The Town of Hilton Head Island Regular Design Review Board Meeting

Tuesday, May 11, 2010

DESIGN TEAM/ DRB COMMENT SHEET

PROJECT Wexford Clubhouse DRB# DR090041

**Wexford
Plantation**
Clubhouse Porte-Cochere
Hilton Head Is., SC 29928

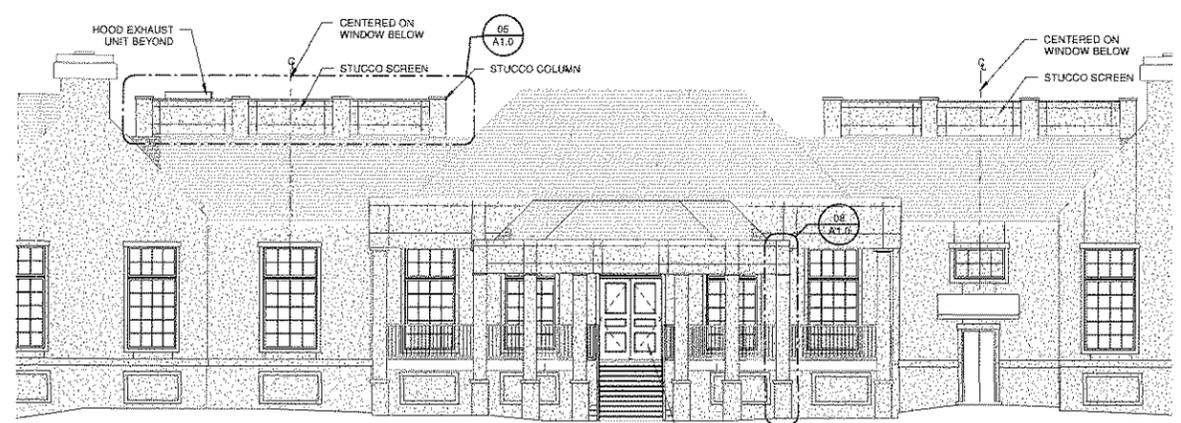
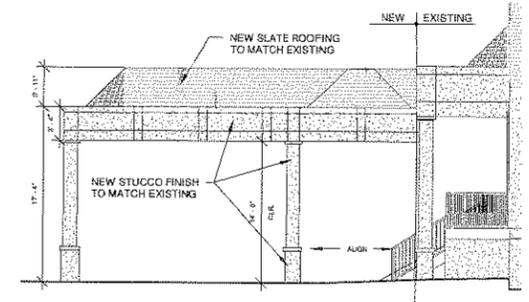
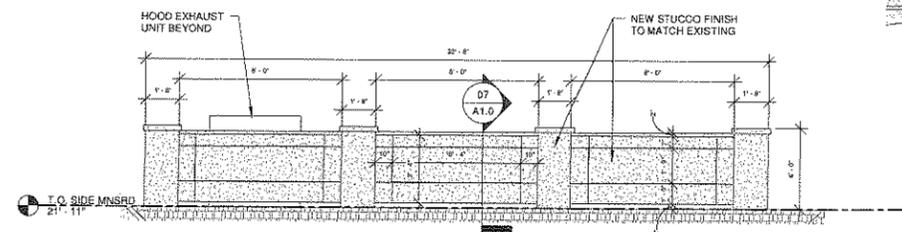
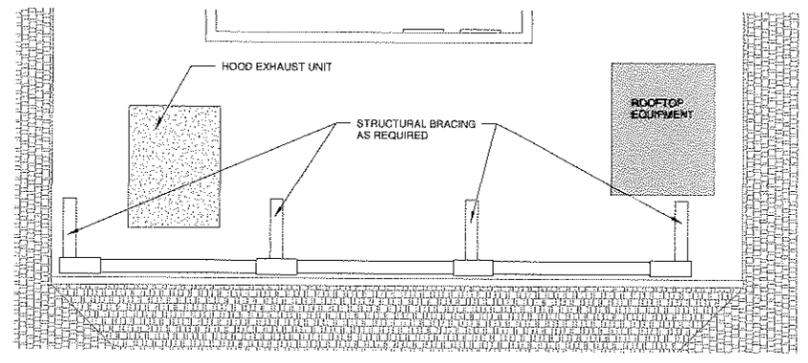
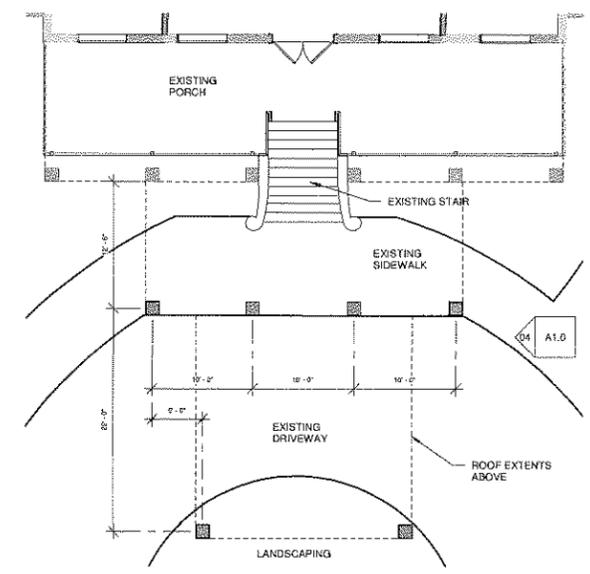
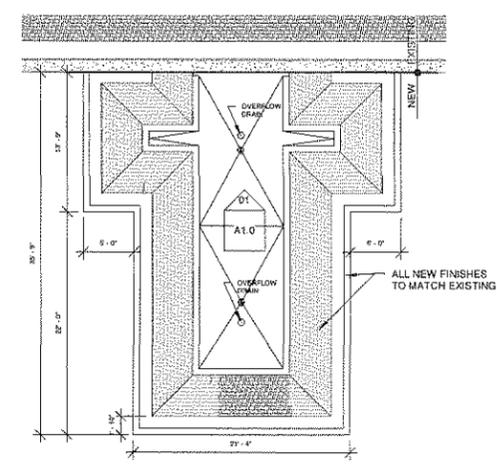
ARCHITECTURAL DESIGN		
Update to a previously approved clubhouse renovation. The porte-cochere integrates successfully into the existing details of the clubhouse and is a provides a substantial element to the front of the clubhouse. The screen detail picks up on existing elements on the clubhouse, as well.		
DESIGN GUIDE/LMO CRITERIA	COMPLIES YES/NO/N/A	COMMENTS OR CONDITIONS
Structure is designed to be appropriate to the neighborhood		
Promotes pedestrian scale and circulation		
Design is unobtrusive and set into the natural environment		
Utilizes natural materials and colors		
Avoids distinctive vernacular styles		
Design is appropriate for its use		
All facades are have equal design characteristics		
Avoids monotonous planes or unrelieved repetition		
Has a strong roof form with enough variety to provide visual interest		
Minimum roof pitch of 6/12		
Overhangs are sufficient for the façade height.

SOUTH ISLAND
PUBLIC SERVICE DISTRICT
PALMETTO BAY ROAD
HILTON HEAD ISLAND, SC

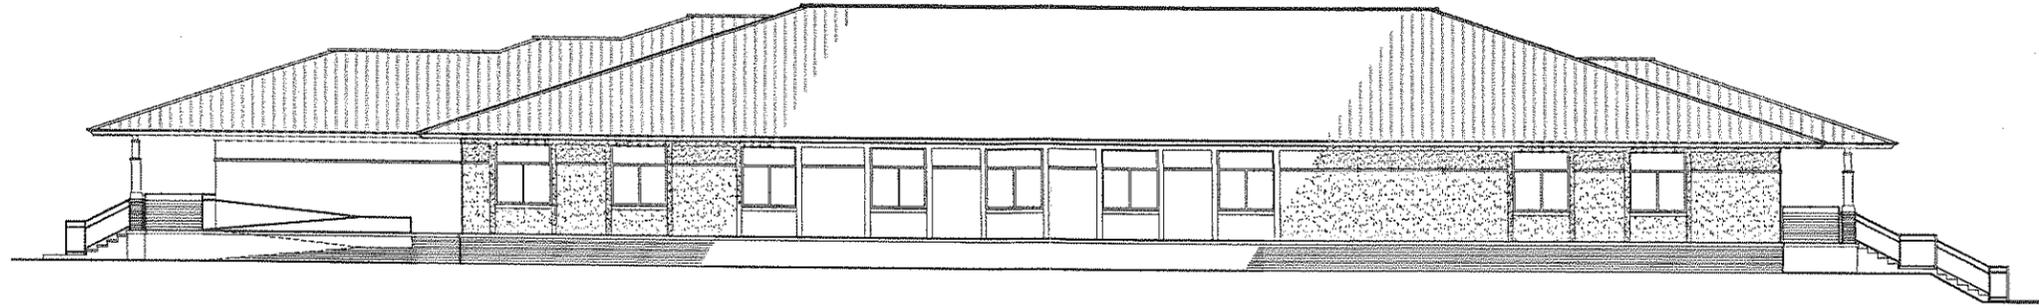
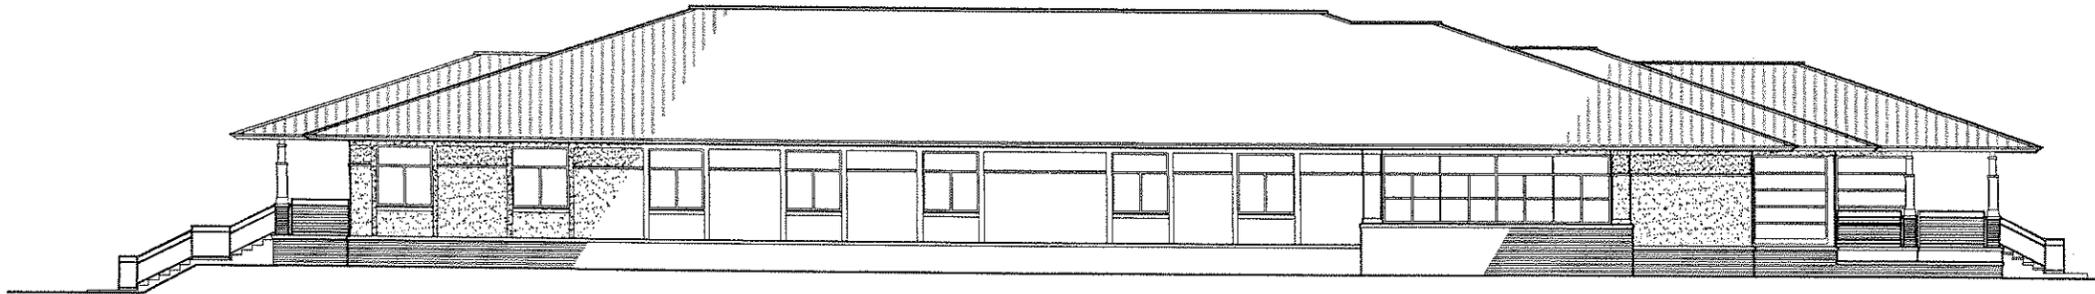
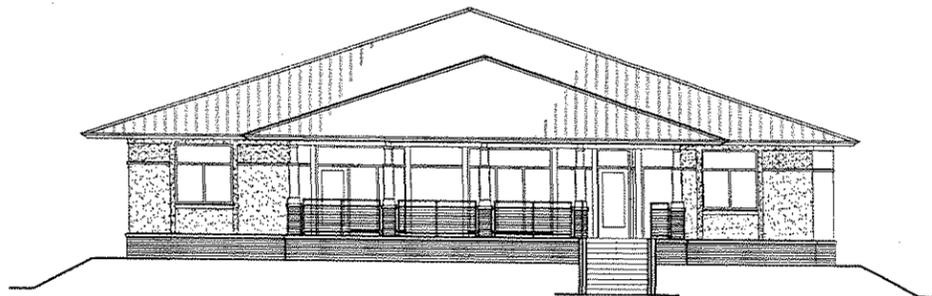
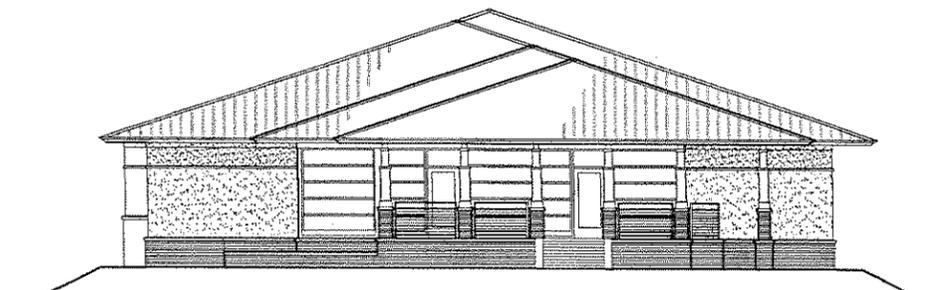
ARCHITECTURAL DESIGN		
Conceptual submittal for development. No material colors provided. Narrative indicates they will be provided at meeting. Project aims to reach LEED silver rating.		
DESIGN GUIDE/LMO CRITERIA	COMPLIES YES/NO/N/A	COMMENTS OR CONDITIONS
Structure is designed to be appropriate to the neighborhood	Y	
Promotes pedestrian scale and circulation	Y/N	It's a drive and park development. Brick and wood elements provide quality and variety on the human scale
Design is unobtrusive and set into the natural environment	Y/N	Lot layout goes some way in preserving significant trees is what is a heavily wooded site
Utilizes natural materials and colors	Y	
Avoids distinctive vernacular styles	Y	
Design is appropriate for its use	Y	
All facades are have equal design characteristics	Y	
Avoids monotonous planes or unrelieved repetition	Y	
Has a strong roof form with enough variety to provide visual interest	Y

Minimum roof pitch of 6/12	None prov.	Roof form is appropriate for the building
Overhangs are sufficient for the façade height.	Y	
Forms an details are sufficient to reduce the mass of the structure	Y	
Human scale is achieved by the use of proper proportions and architectural elements	Y	
Utilizes a variety of materials, textures and colors	Y	
Incorporates wood or wood simulating materials	Y	
Windows are in proportion to the facade	Y	
Details are clean, simple and appropriate while avoiding excessive ornamentation	Y	
Utilities and equipment are concealed from view	Y

Decorative lighting is limited and low wattage and adds to the visual character		None specified
Accessory elements are design to coordinate with the primary structure	Y/N	There is a fence and gate labeled on the plan, but no detail provided.

**NARRATIVE IN SUPPORT OF
PROPOSED CANOPY
WISE GUYS
MAIN STREET VILLAGE**

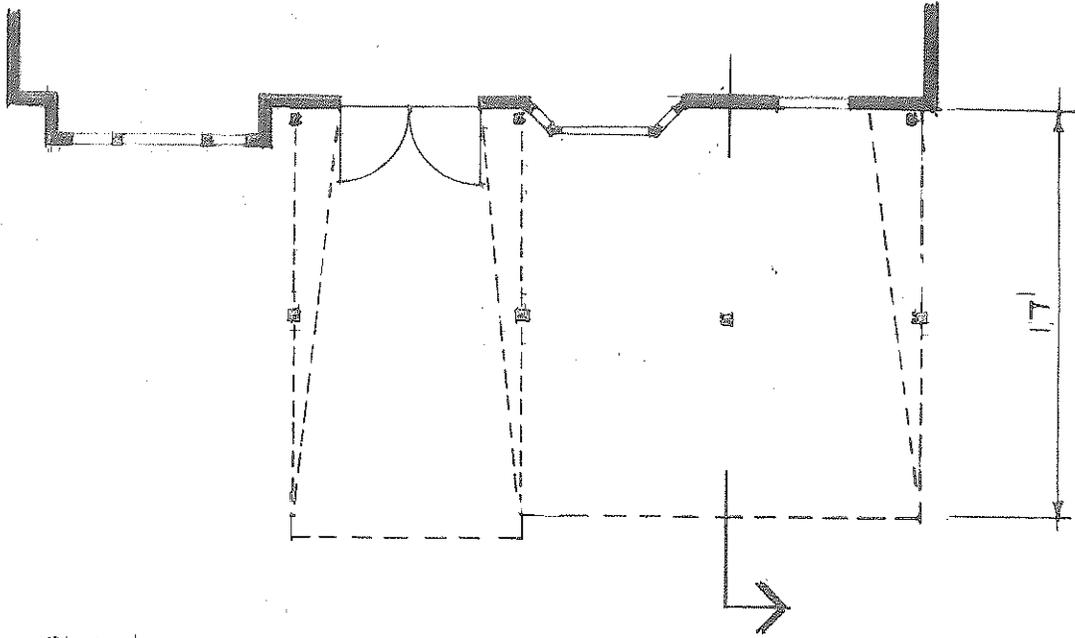
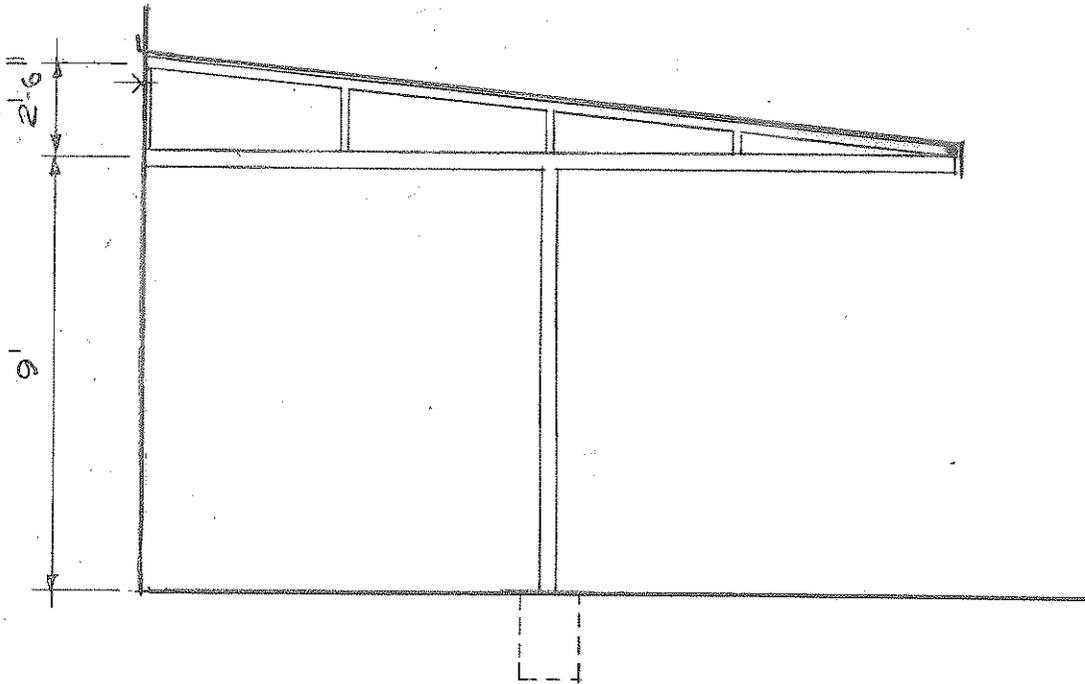
Application proposes a burgundy canopy. Material sample to be provided at meeting for color verification. Section doesn't verify a fascia or valance, although elevations would indicate one of about 8-12". There is currently a domed awning next to an asphalt gable roof element and a standing seam roof over the bay window element. While the hipped canopy does little to unify the two remaining elements, it certainly isn't anymore discordant than what is existing. The bay element almost seems superfluous under the canopy. Hard to tell how the canopy relates to the ground plane, because no site plan is provided. Encasing the posts might also help tie the canopy into the building more. Staff would recommend approval with the provision of a dimensioned site plan and a detailed drawing showing some post treatment for the Board's approval. The canopy, in theory, is approvable, there are just some details that need clarified.
